REMARKS

Appl. No. 09/957,496
Reply to Office Action of November 30, 2004
Annotated Sheet Showing Changes

FIG. 1

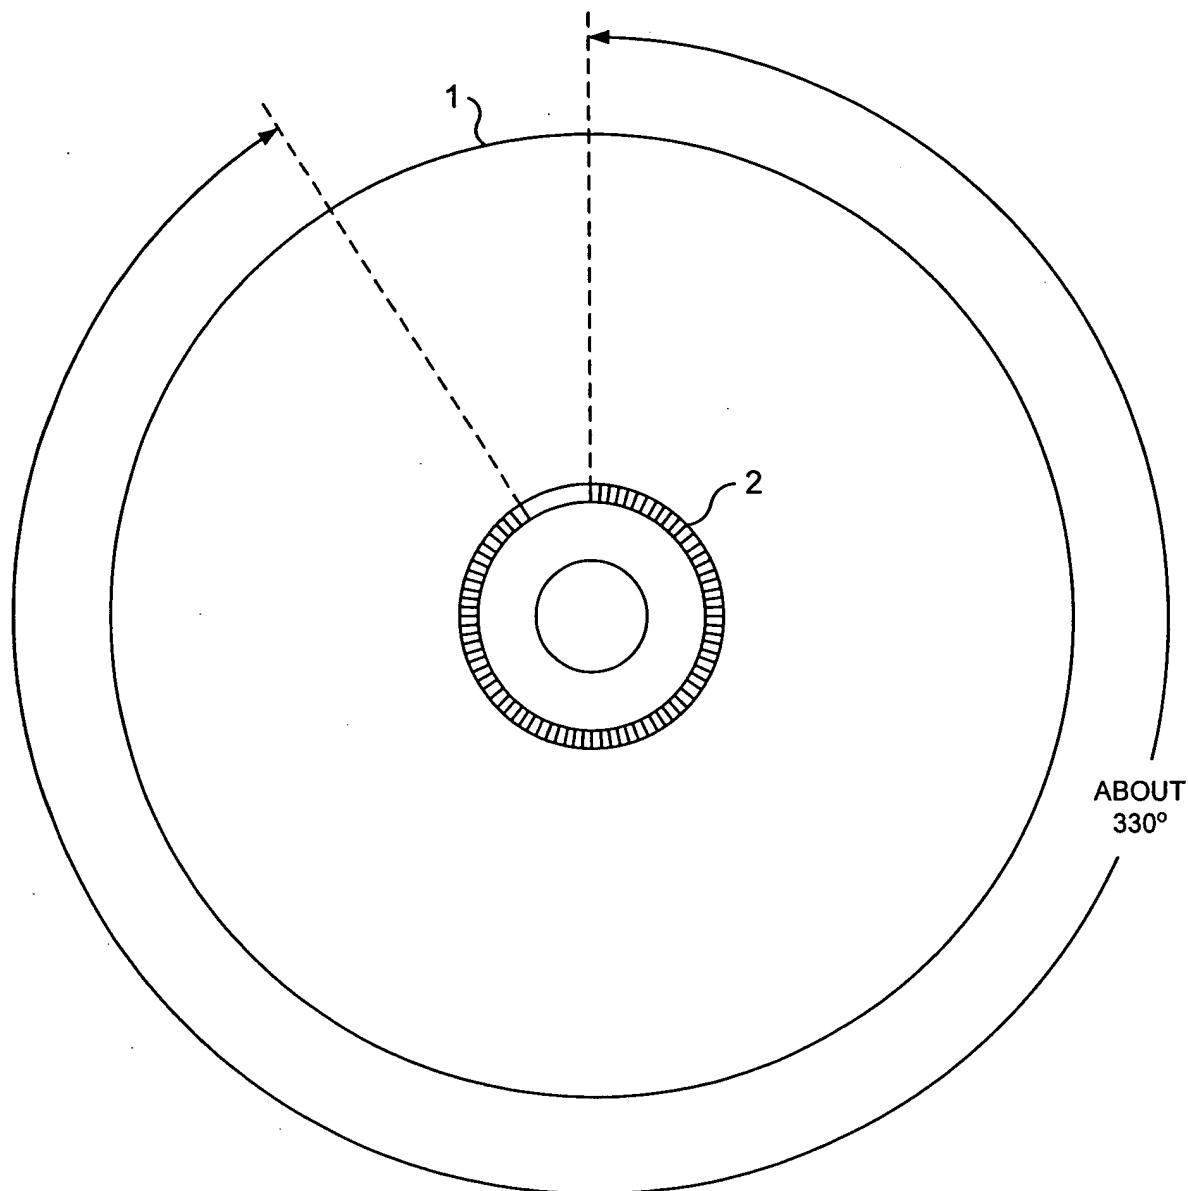
In Section 2 of the Office Action, Figures 1 and 2 are objected to for failing to designate the figures as Prior Art.

The attached sheets of drawing include change to FIG. 1 and FIG. 2. These sheets replace the original sheets including FIG. 1 and FIG. 2. In Figure 1, a legend labeled "Prior Art" has been added. In Figure 2, a legend labeled "Prior Art" has been added.

(PRIOR ART)

Legend Added
